UNITED STATES DEPARTMENT OF COMMERCE
Patent and Trademark Office

APPLICATION NO.	FILING DATE	FIRST NAMED INVENTOR	ATTORNEY DOCKET NO.
09/556,829	04/21/00	KUHLMANN-WILSDORF	D 10582-0002-2

Office Action Summary

DETAILED ACTION

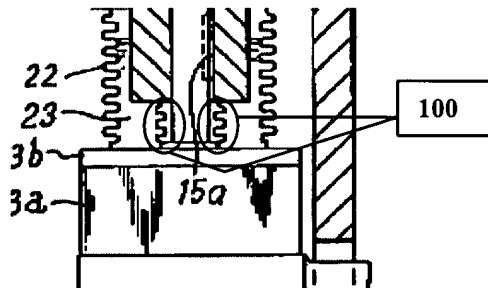
Dobbing et al. clearly teaches the construction of an electrical brush holder for applying a mechanical force to an electrical brush (13), comprising:

a first wall (22) fastened to a current conducting element (16a);

a second wall (13b) configured to be fastened to the brush;

a sidewall (21) lengthwise extending in an axis direction of the brush and cooperating with the first and second walls to form a volume defined by the first wall, the second wall and the sidewall; and

a fluidic medium (23) contained in the volume and configured to apply a pressure to the brush via the second plate.

13. With regards to claim 3, Dobbing et al. discloses an electrical brush holder wherein said fluidic medium comprises a gas (100, added by the examiner for convenience) and a liquid metal (23) in pressure-transmitting contact with each other via at least one flexible membrane (21).
